City of Portland, Maine - Building or Use Permit

Permit No: 07-1265	Date Applied For: 10/10/2007	CBL: 045 E028001
------------------------------	--	----------------------------

Proposed Use: Two Family/Replace deck	Proposed Project Description: After the fact permit for deck and stairs
---	---

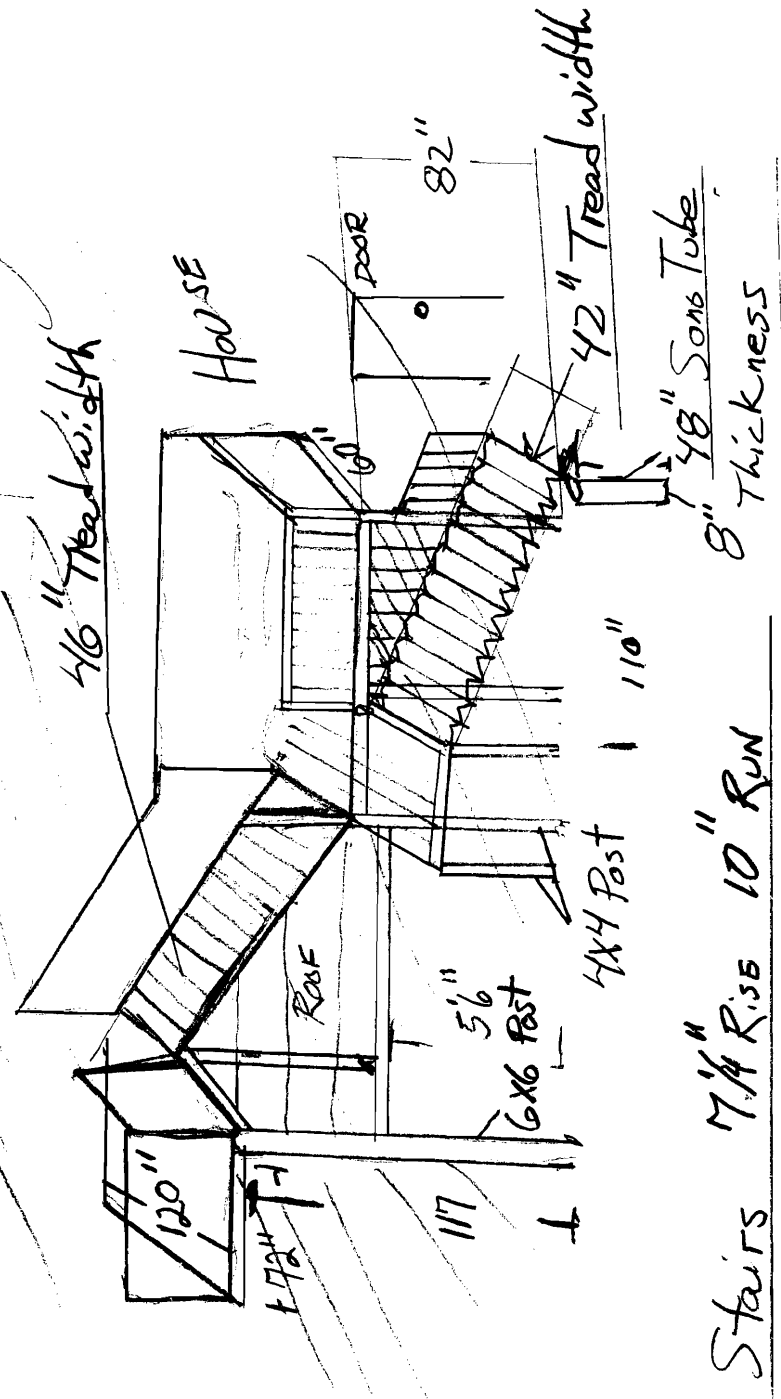
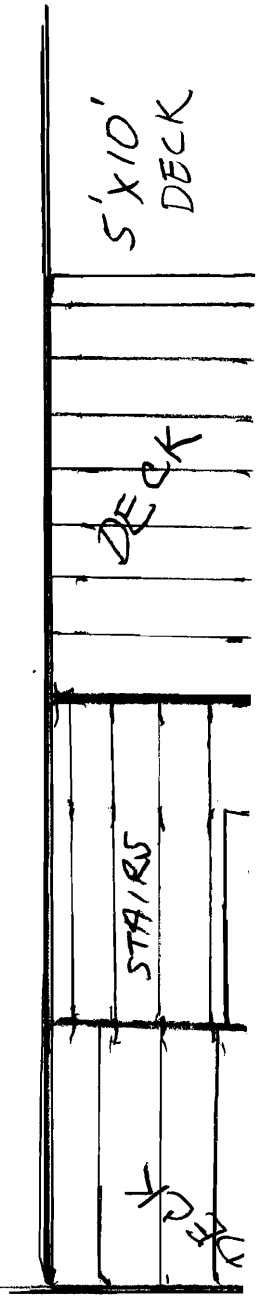
Dept: Building **Status:** Approved with Conditions **Reviewer:** Chris Hanson **Approval Date:** 12/07/2007
Note: Stairs must run parallel w/ bldg. Ck setbacks 12/072007 rec'd plan showing stair detail CSH **Ok to Issue:**

1) As discussed during the review process, ballusters must be spaced with less than a 4" opening between each.
2) Application approval based upon information provided by applicant. Any deviation from approved plans requires separate review and approval prior to work.

3) Open risers are permitted, provided that the opening between treads does not permit the passage of a 4" diameter sphere.
4) Maintain proper setback(s) from property lines/buildings

5) As discussed during the review process, ballusters must be spaced with less than a 4" opening between each.
6) Fastener schedule per the IRC 2003
7) Your guardrail system installed around your deck must meet the loading requirements of section 1607.7.1 of the IBC 2003 Building Code.

8) Frost protection must be installed per the enclosed detail as discussed w/owner/contractor.
9) ANY exterior work requires separate review and approval thru Historic Preservation

Stairs 7 1/4" Rise 10" Run

Railings 40" Height 4" Spacing

Descriptor/Area

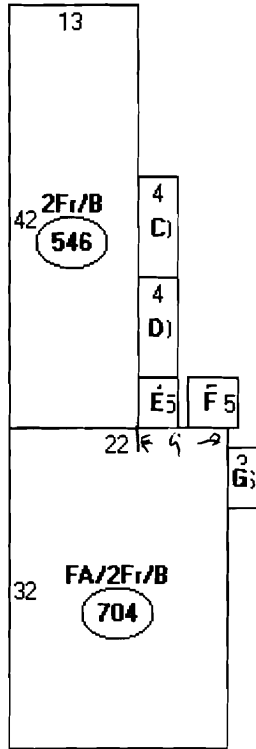
rear - 20' req. - 41' b back of house (ok)

side - 10' req. - ? *

lot coverage 50% = 2406.5 sq ft
ok
1463 sq ft

* owner says that driveway is 10' wide that the stairs will go to the edge of the driveway.
